DEPARTMENT OF TRANSPORTATION

National Highway Traffic Safety Administration

Anthropomorphic Test Devices; 12-Month-Old Child Dummy

ACTION: Final rule.

Figure R 5
THORAX IMPACT TEST SET-UP SPECIFICATIONS

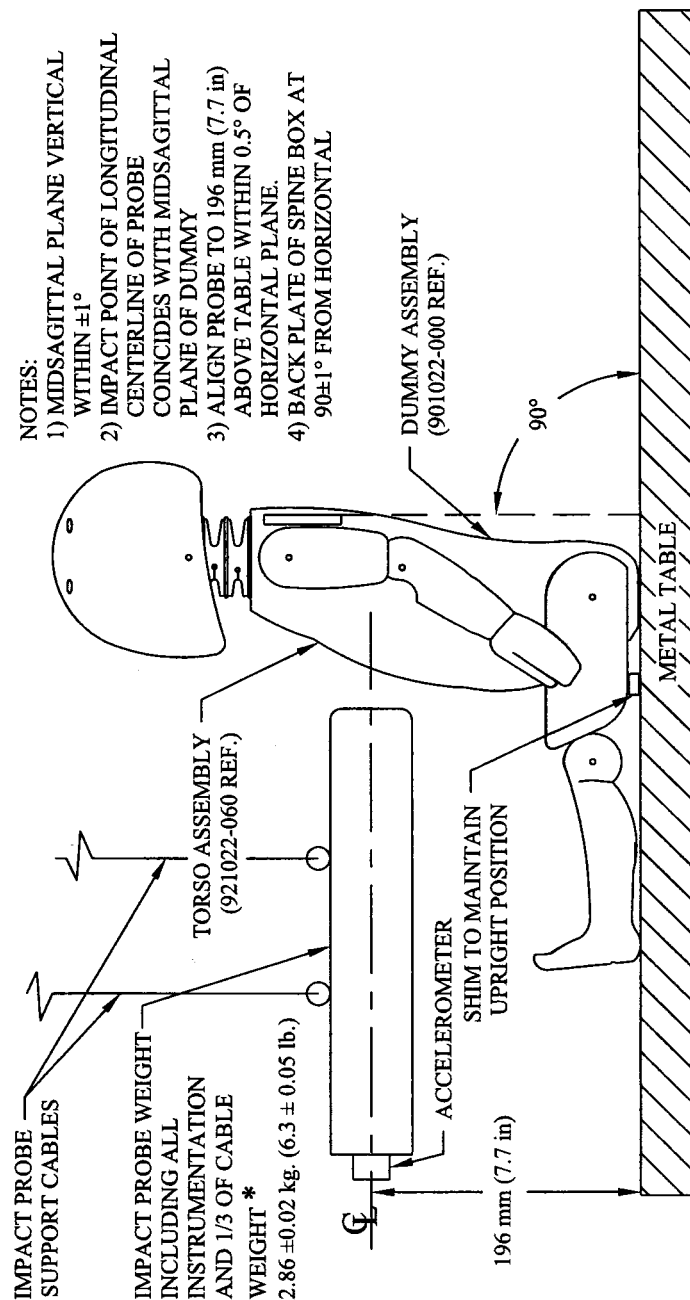
TRC suggests that the positioning of the dummy in the thorax assembly test procedure needs to be modified to match the placement shown in proposed Figure R5. The proposed regulatory text (§ 572.154(c)(3)) stated that the dummy is positioned with fingers barely touching the seating surface plane. However, Figure R5

showed the dummy’s fingers as well above the seating surface. We agree that the dummy’s arms are too short for the fingers to touch the seating surface plane and have made the necessary corrections to § 572.154(c)(3).
